**Year 1 Monitoring Report**

**UT WEST BRANCH ROCKY RIVER  
RESTORATION SITE**

NCDMS Project #92684 (Contract # WBRR010521)  
USACE Action ID: SAW-2017-00342 | NCDWR Project #18-1696

RE: UT West Branch Rocky River Project: Year 1 Monitoring Report

# MY1 2021 UTWBRR UT1 Flow Gauge

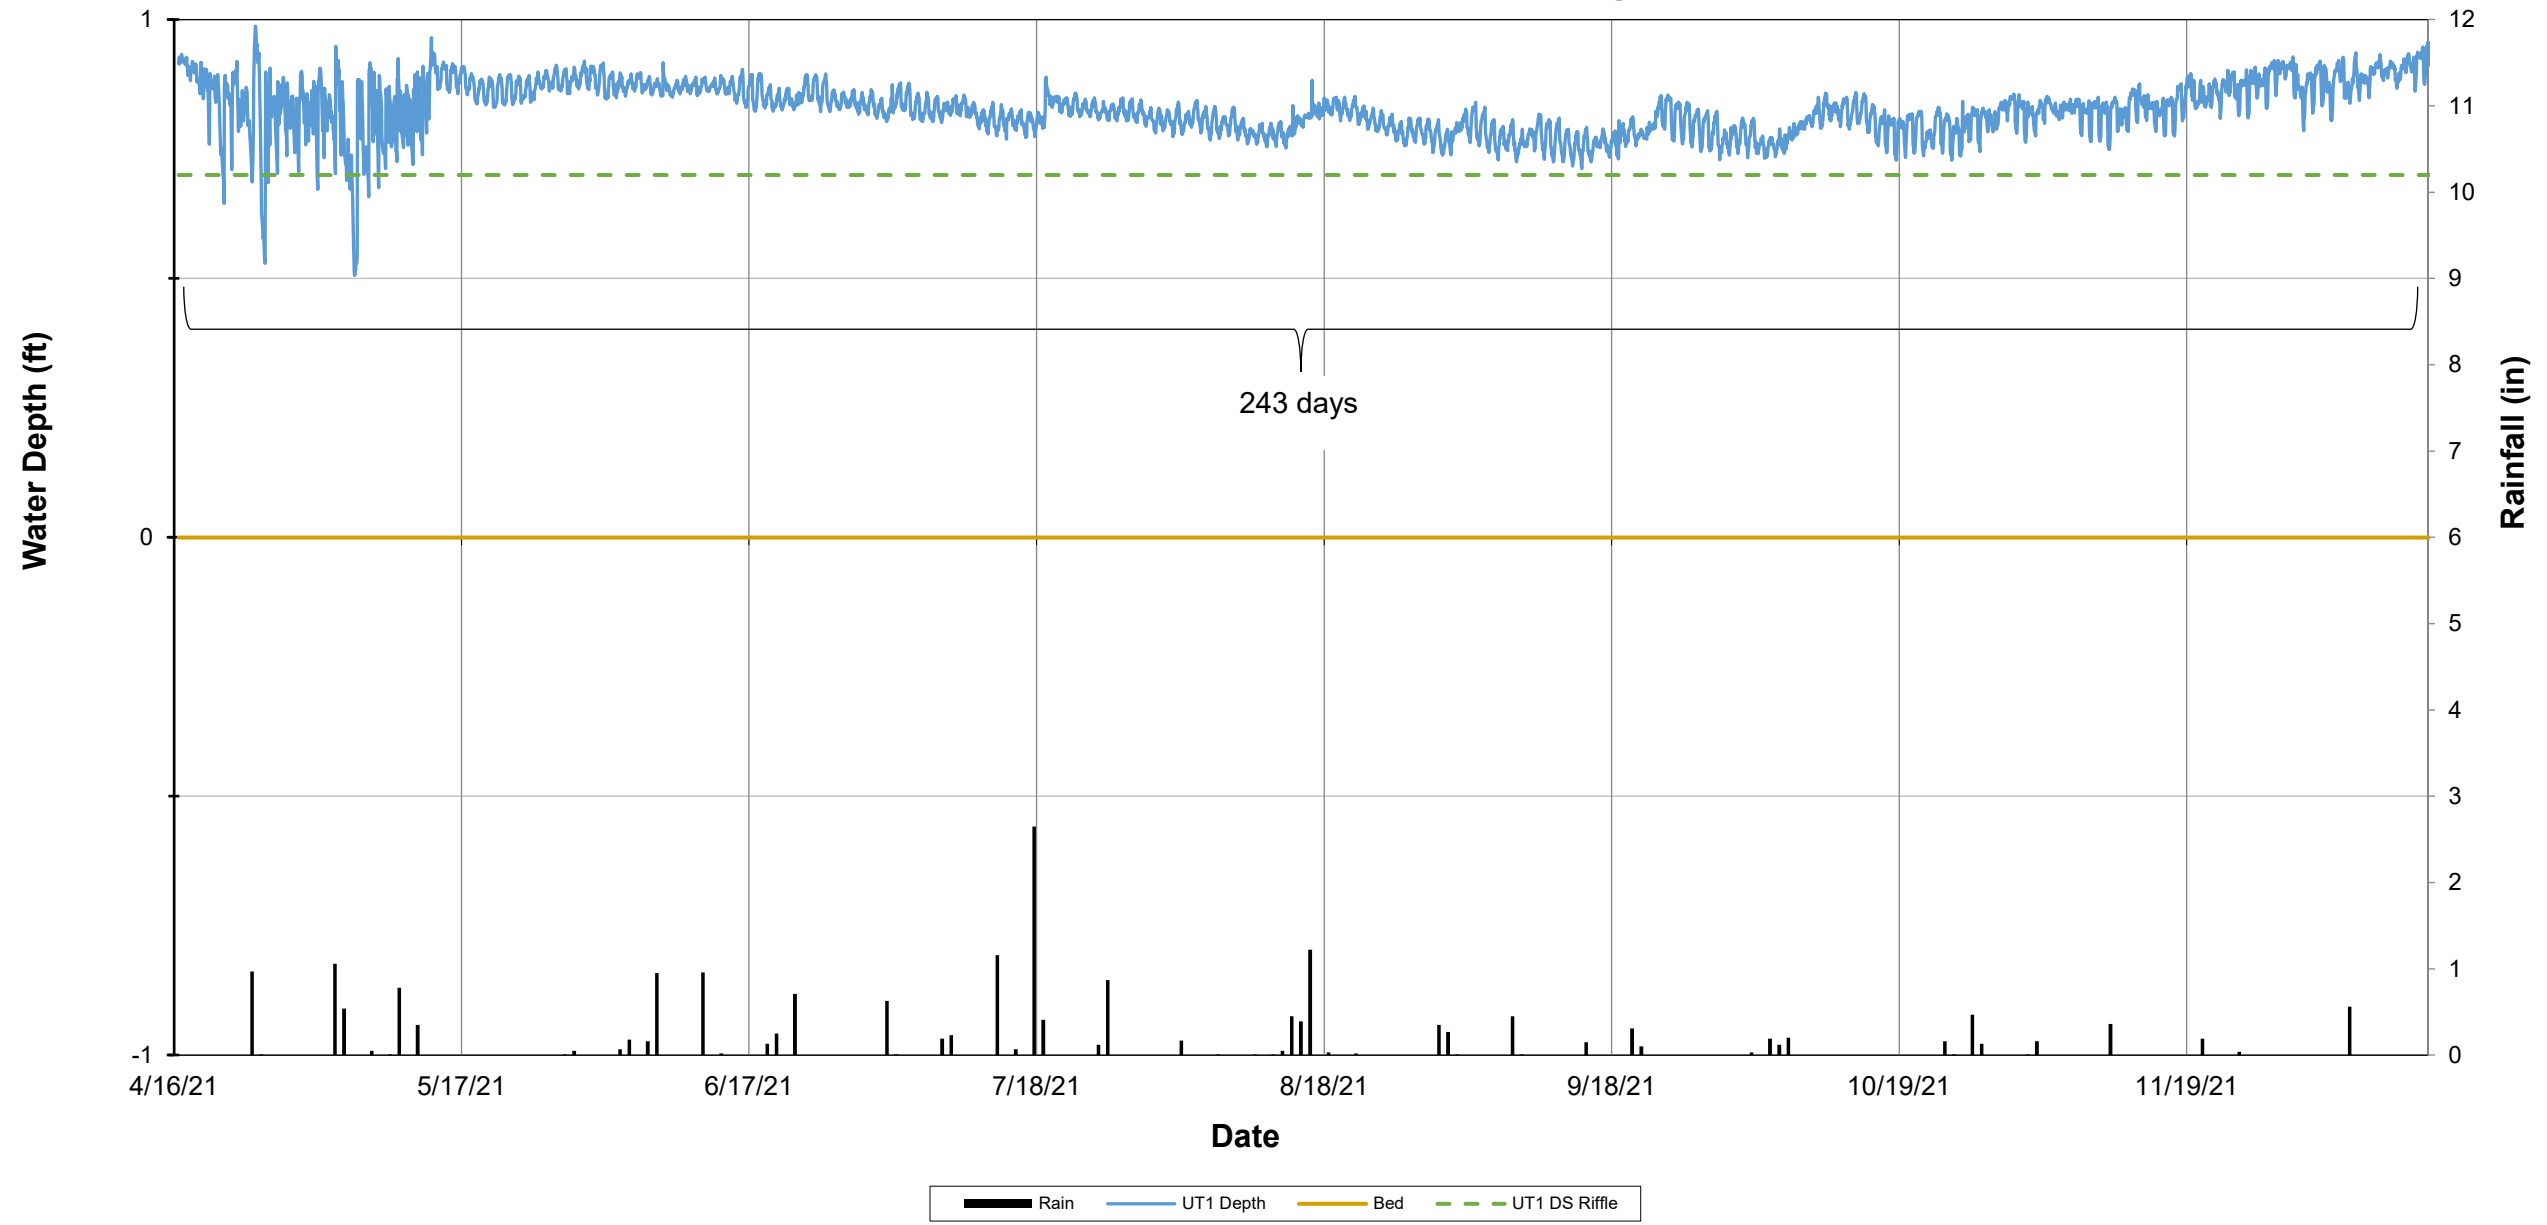
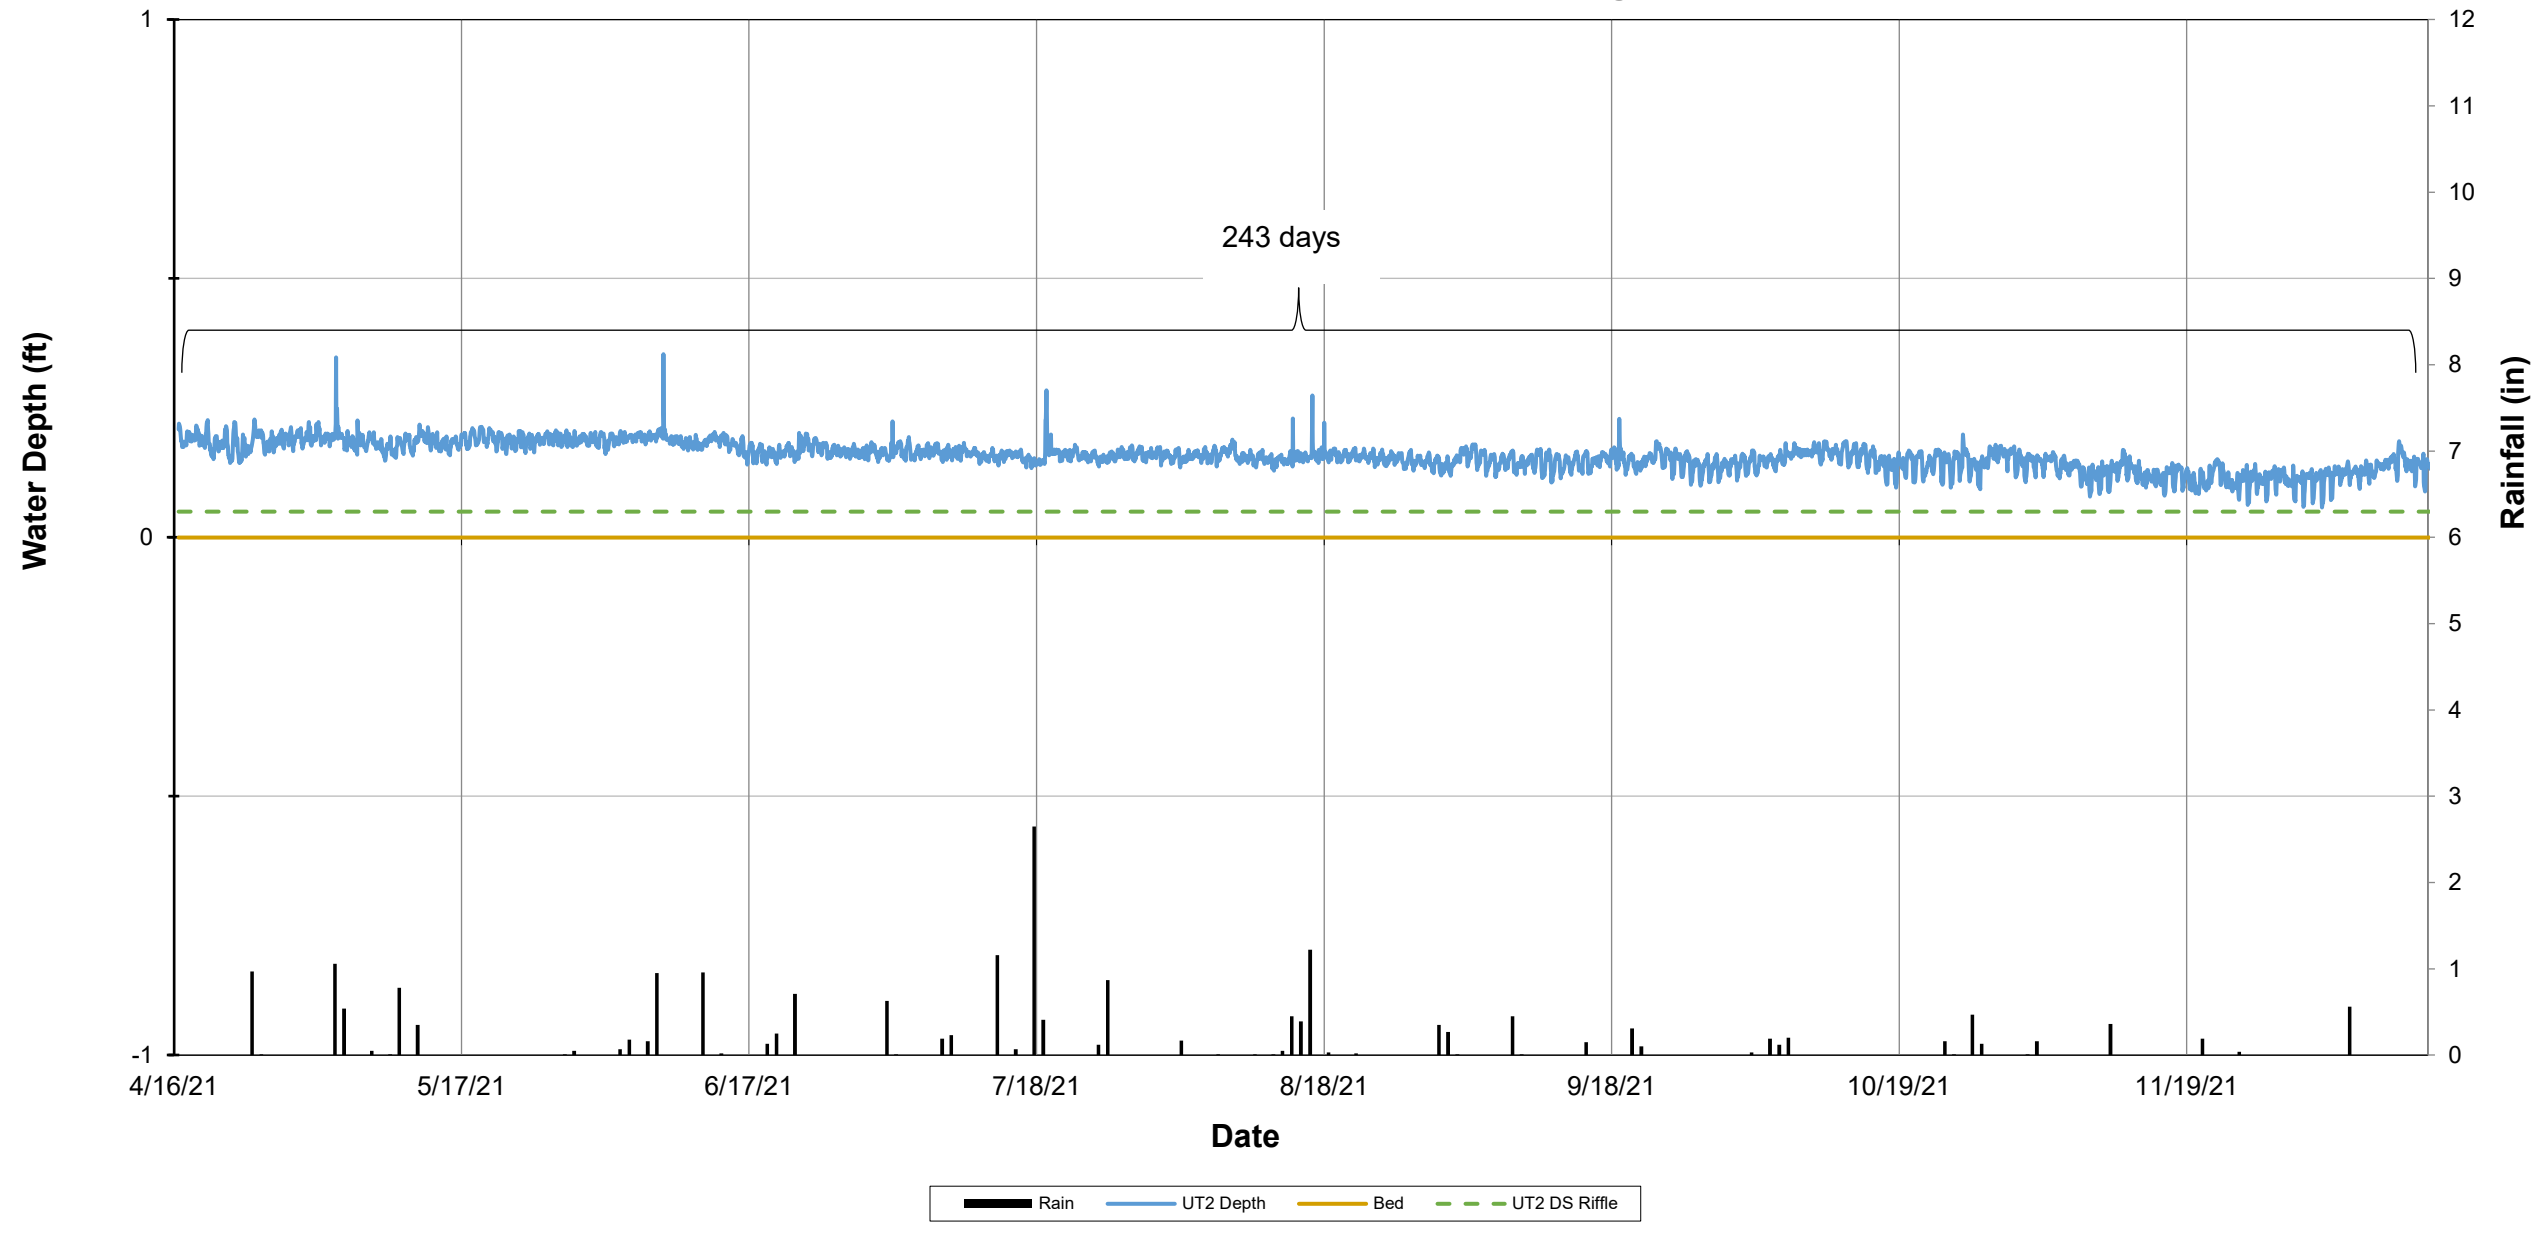
- Please indicate the consecutive days of flow on the flow gage graph and bracket the corresponding period on the graph.  
[Done.](#)
- RES states that *"In MY1, the stage recorder did not record any bankfull events. Additionally, no visual evidence of bankfull events were observed. If any bankfull events are recorded in late 2021, they will be included in the MY2 report."* It is unusual that a bank full event did not occur, given several major rain events throughout the year, in particular one in mid-August. What frequency were data recorded? Were the transducers fully functional, and if so, why did it not pick up the August storm event? Did RES search for visual indicators? This channel was just constructed and is well connected to the floodplain. Crest gages and/or transducers should be inspected and downloaded quarterly or semi-annually. Evidence of bankfull events such as rack lines or floodplain deposition should be documented with a photo when possible. Transducers should be set to record stage once every three hours. Please note that the credit release associated with the bank full standard cannot occur until the MP-approved credit release schedule bank full standard is met. If any bankfull events are recorded in late 2021, they should be included in the MY1 report.
